Individual Plant Examination Program: Perspectives on Reactor Safety and Plant Performance

Part 6

Appendices A, B, and C

Division of Systems Technology
Office of Nuclear Regulatory Research
U.S. Nuclear Regulatory Commission
Washington, DC 20555-0001

Figure C.1 Comparison of NUREG-1150 and Westinghouse seal LOCA models — old o-ring elastomer.

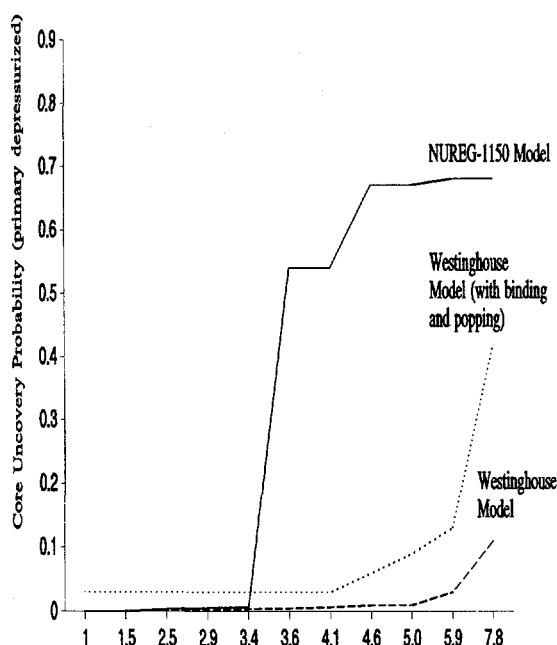
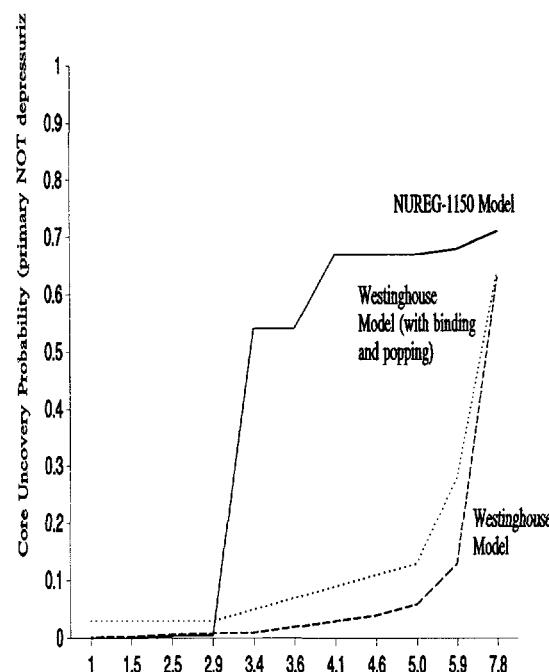
11. **Comment:** It is not clear from the information presented that the Westinghouse RCP seal LOCA model provides a lower contribution to CDF than the IPEs that used the NUREG-1150 model.

Since this is very important to many plants, it is recommended that NUREG-1560 provide a detailed comparison of the two approaches. One of the dominating factors in the seal LOCA model is the probability of core uncovering occurring within the first hour. IPEs using the Westinghouse RCP seal LOCA model typically use 0.0283 and the NUREG-1150 model uses 0.0. The NUREG-1150 model does not consider any seal leakage for the first 90 minutes. From these facts it appears that the Westinghouse RCP seal LOCA model is more conservative. (Reference: see Table C.1, #16)

A comparison of the seal LOCA probabilities from the two models was not possible due to the unavailability of the reports documenting the Westinghouse model (with and without seal binding and popping open included). However, the Point Beach IPE and the response to questions concerning the Farley IPE did provide

an opportunity to compare the core uncover probability as a function of time for cases involving RCPs equipped with the old o-ring elastomer with the vessel either depressurized or not depressurized, and with the RCPs tripped. A comparison of the values from these curve fits with the core uncover times calculated for identical cases for the Surry plant, as reported in NUREG-1150, Volume 3, is provided in Figure C.1. The curve fit is only valid over the time frame of 30 minutes to 8 hours. It should be noted that Point Beach is a two loop plant

while Surry and Farley are three loop plants and thus the core uncover time for a given leak rate could be different. However, since the reactor coolant system volumes for the plants are roughly scaled by the number of coolant loops, the core uncover times for three plants for the same amount of leakage from each pump should not be substantially different. Thus, the core uncover probability comparison in Figures C.1 provides a reasonable picture of the differences between the NUREG-1150 and Westinghouse seal LOCA models.

Figure C.1 indicates that all three models predict small probabilities of leaks and core uncover for early times (less than about 3 hours). Because of this, differences between the three models do not have a significant impact on CDF for this early time period. However, for later times, the differences are more significant. The Westinghouse models generally predict much

smaller probabilities for core uncover for time periods greater than approximately 3 to 3.5 hours, particularly for cases where the vessel is depressurized. For scenarios where the vessel is not depressurized, however, the probabilities predicted by the Westinghouse models rise sharply at about 8 hours, so that the three models give similar probabilities at that time.

The documented NUREG-1150 seal LOCA model indicates no seal failure prior to 90 minutes. However, after most of the IPEs were completed, an error in the NUREG-1150 model was identified which indicates that there should be some probability of seal failure immediately after loss of seal cooling. Thus, the contribution of RCP seal LOCAs in the IPEs that utilized the NUREG-1150 model is likely underestimated. An evaluation for the NUREG-1150 study for the Sequoyah plant indicates that the seal LOCA contribution was underestimated by 18% (corresponds to a core damage frequency of
